Project No. 2008-007

Subject: Addendum No. 1
Preliminary Materials Report
Grove Avenue Corridor Project
Project No. ST0302
Ontario, California

Figure 1 - PAVEMENT THICKNESS RECOMMENDATIONS - GROVE AVENUE AND FOURTH STREET

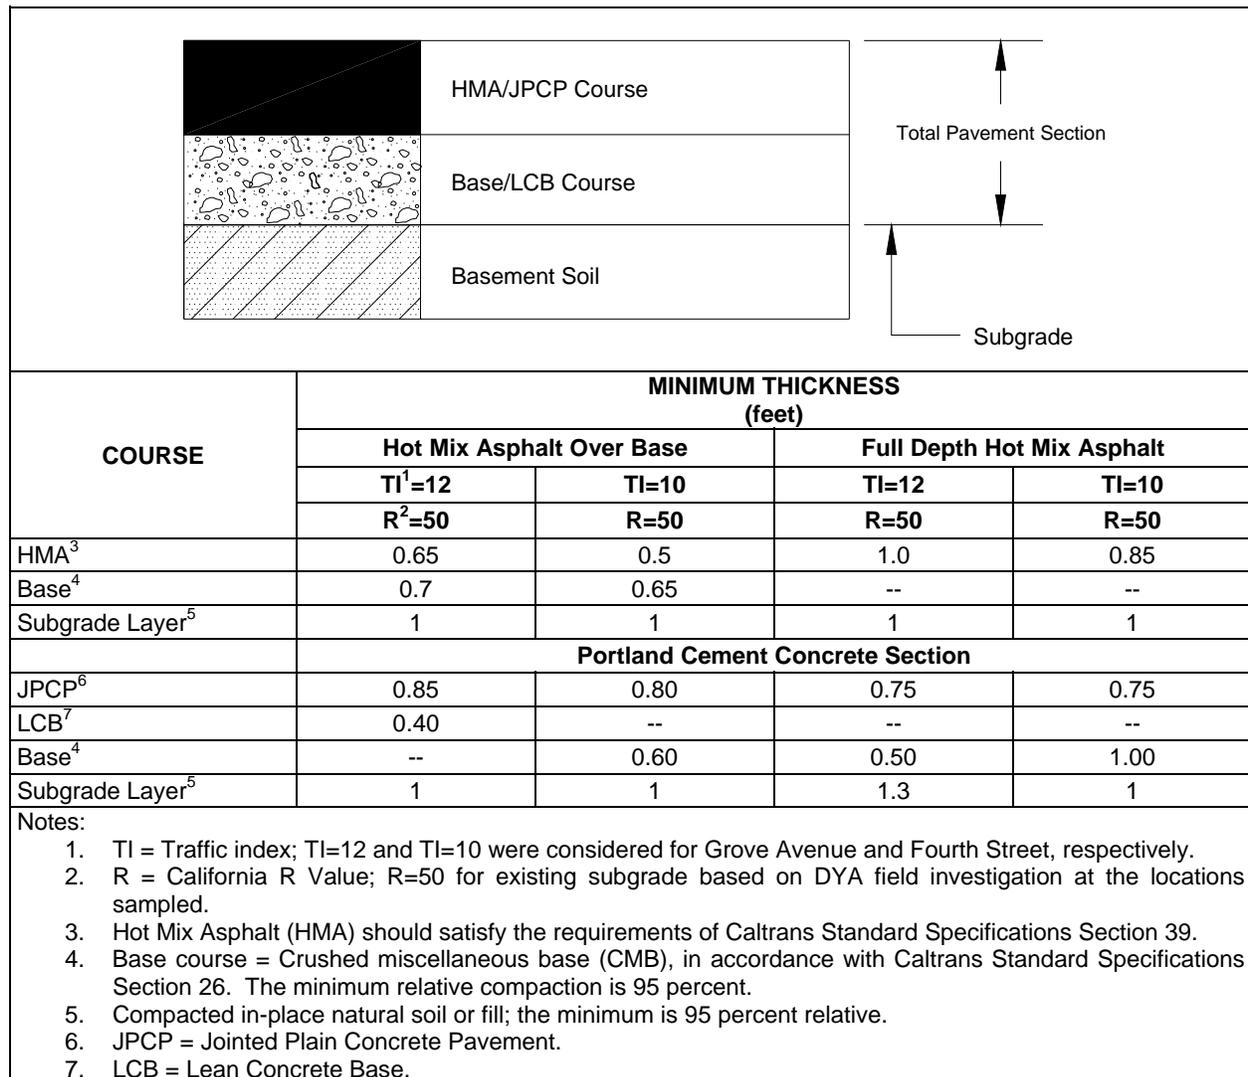
The revised pavement recommendations for Grove Avenue and Fourth Street are provided on Figure 1. Recommendations for freeway pavement sections based on assumed subgrade characteristics are included on Figure 2.
